PARTIDGE – WOOD SUBDIVISION

FINAL PLAT COMMENTS (should be addressed prior to submitting the FINAL PLAT for review and/or signature by the City Engineer):

APPLICATION NUMBER 5 DATE May 21, 2020

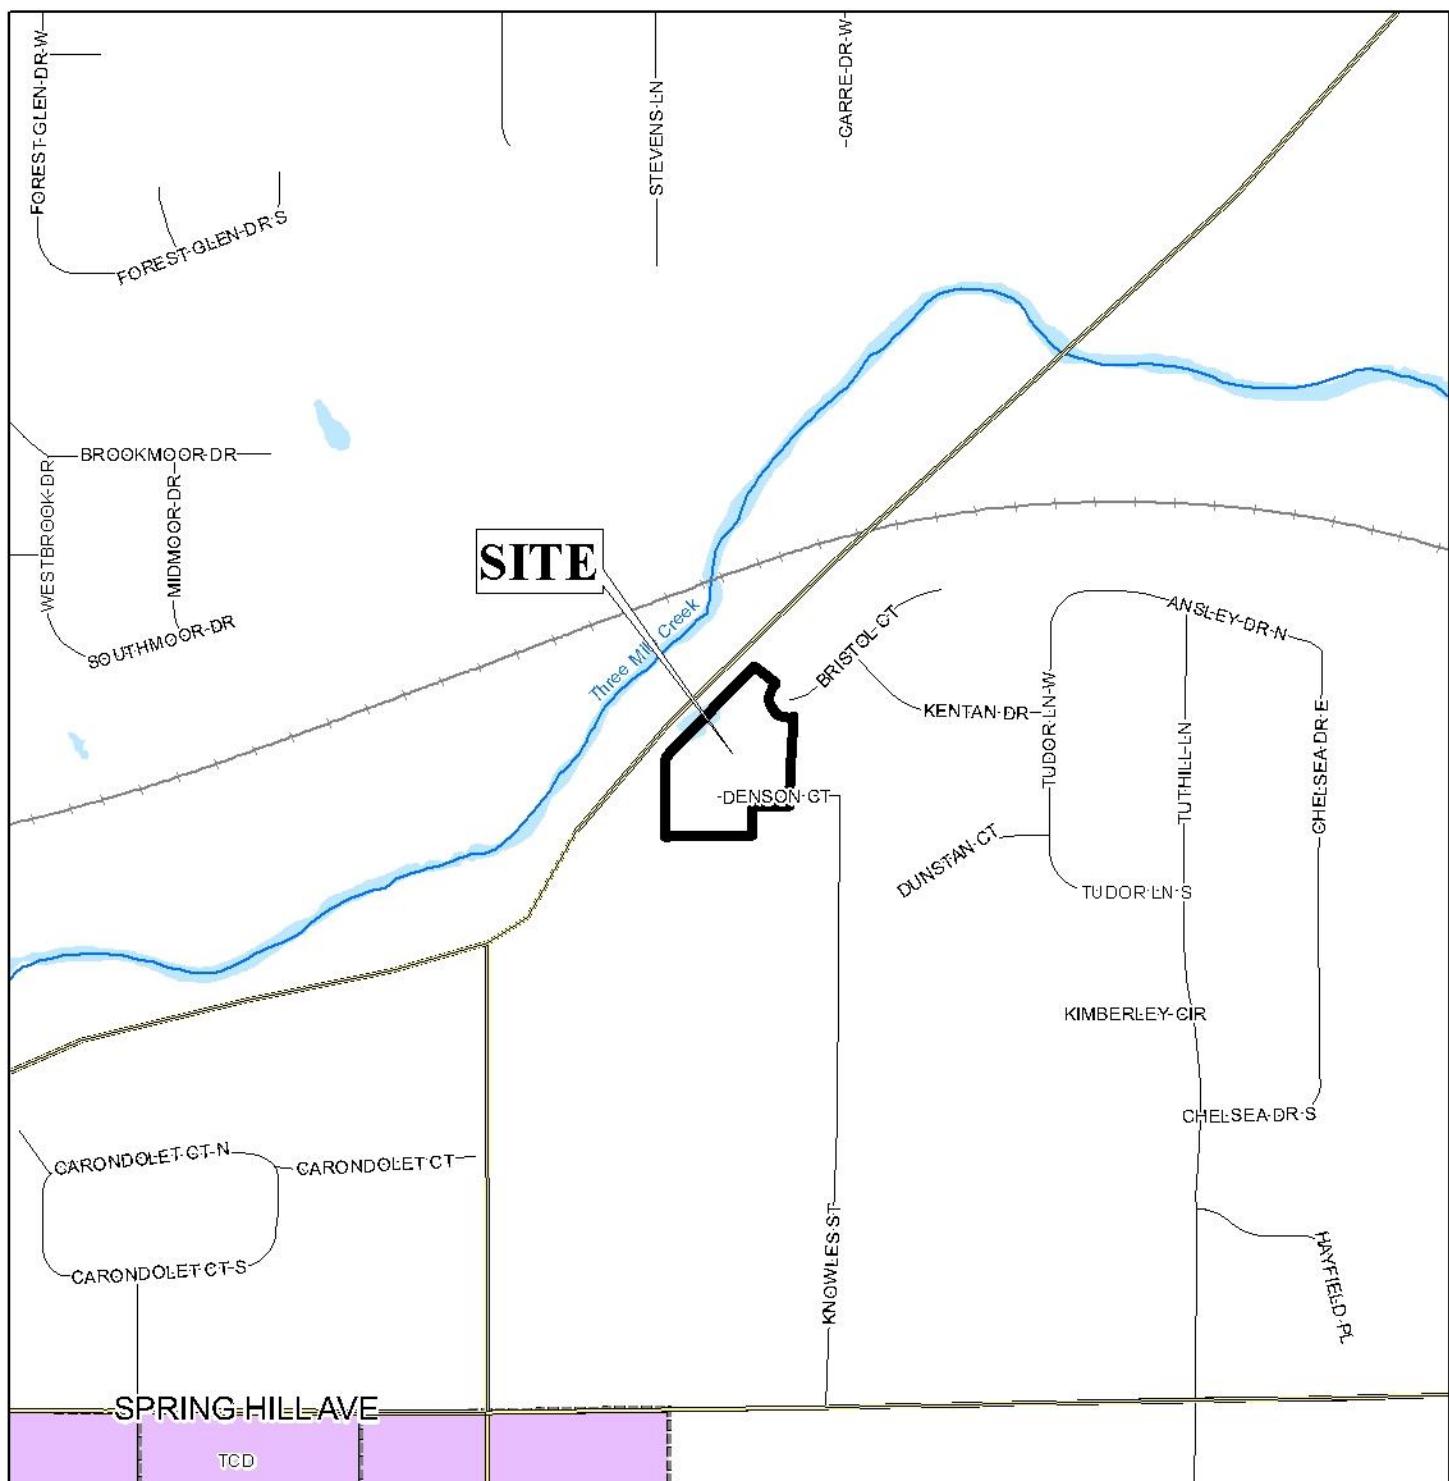
The proposed Lot 1 fronts Bristol Court, a minor street with curb and gutter requiring a 50-foot right-of-way. Lot 2 has frontage on both Bristol Court and Denson Court, a minor street without curb and gutter which typically requires a 60-foot right-of-way width. However, at the April 5, 1973 meeting of the Planning Commission, the Denson Court Subdivision was approved illustrating a 50-foot right-of-way width for this portion of Denson Court. As such, and with a waiver of Section V.B.14. of the Subdivision Regulations, a reduced right-of-way width may be appropriate and should be reflected as such on the Final Plat, if approved. The preliminary plat does not label either street right-of-way width, and if approved, the Final Plat should be revised to either illustrate existing compliant right-of-way widths of 50-feet for both frontages, or provide dedication to provide 25-feet from the centerline.

The preliminary plat does not illustrate setbacks along the frontages of either of the proposed lots. As such, if approved, the Final Plat should be revised to illustrate a 25-foot minimum building setback line along all frontages for both lots.

In accordance with the Subdivision Regulations, the proposed lots exceed the minimum lot size requirement. If approved, the lot size labels in both square feet and acres should be retained on the Final Plat or a table should be furnished on the Final Plat providing the same information.

As a means of access management, a note containing the Traffic Engineering comments should be placed on the Final Plat. Additionally, as easements are recorded on the subject property they should be indicated and labeled on the Final Plat, and a note should be placed on the Final Plat stating that no structures shall be constructed or placed within any easement.

Based upon the preceding, and with a waiver of Section V.B.14. of the Subdivision Regulations, the plat meets the minimum requirements of the Subdivision Regulations and is recommended for Tentative Approval, subject to the following conditions:

- 1) revision of the Final Plat to either illustrate a 50-foot right-of-way for both Bristol Court and Denson Court, or dedication to provide 25-feet from the centerline;

- 2) revision of the Final Plat to illustrate a 25-foot minimum building setback along Bristol Court and Denson Court;
- 3) retention of the lot size labels in both square feet and acres on the Final Plat or the furnishing of a table on the Final Plat providing the same information;

- 4) placement of a note on the Final Plat stating that no structure may be placed or constructed within any easement;
- 5) compliance with the Engineering comments: (*FINAL PLAT COMMENTS* (should be addressed prior to submitting the FINAL PLAT for review and/or signature by the City Engineer): A. Provide all of the required information on the SUBDIVISION PLAT (i.e. signature blocks, signatures, certification statements, written legal description, required notes, legend, scale, bearings and distances) that is required by the current Alabama State Board of Licensure for Professional Engineers and Land Surveyors. B. Show and label the POB. C. Provide and label the monument set or found at each subdivision corner. D. Add street names to the vicinity map. E. Review and revise the written legal description or written bearing/distances along the west line of LOT 2. F. National Wetlands Inventory (NWI) mapping, as shown on City of Mobile GIS information, indicates that there is potential for wetlands within the property or properties shown on this plat. Show and label the delineated wetlands, or provide a note stating that the wetlands shown on this plat are scaled from the NWI data and have not been delineated. G. Provide a note that a 25' riparian buffer may be required, during development, along the edge of anything considered by ADEM to be a water of the state. H. Show and label all flood zones. I. Show and label the MFFE (Minimum Finished Floor Elevation) on each lot that contains an AE, V, or X (shaded) flood zone designation. J. Add a signature block for the Owner, Notary Public, Planning Commission, Traffic Engineer, and City Engineer. K. Provide the Surveyor's Certificate. L. Provide the Surveyor's, Owner's (notarized), Planning Commission, and Traffic Engineering signatures. M. The proposed CITY OF MOBILE DRAINAGE EASEMENT will need to be revised. The area along the east property line is receiving drainage from a public street and will require a PUBLIC (Dedicated to the City of Mobile) drainage easement; the width and alignment of the easement shall be coordinated with, and approved by, the City Engineer prior to submitting the Plat for signatures. N. Add a note to the SUBDIVISION PLAT stating that as shown on the 1984 aerial photo (FLIGHT 23 - #70) LOTS 1 and 2 will receive historical credit of existing (1984) impervious area towards stormwater detention requirement per Mobile City Code, Chapter 17, Storm Water Management and Flood Control) as follows: LOT 1 - NONE, LOT 2 -NONE. O. Add a note to the SUBDIVISION PLAT stating that a Land Disturbance permit will be required for any land disturbing activity in accordance with Mobile City Code, Chapter 17, Storm Water Management and Flood Control; the City of Mobile, Alabama Flood Plain Management Plan (1984); and, the Rules For Erosion and Sedimentation Control and Storm Water Runoff Control. P. Add a note to the Plat stating that the approval of all applicable federal, state, and local agencies (including all storm water runoff, wetland and
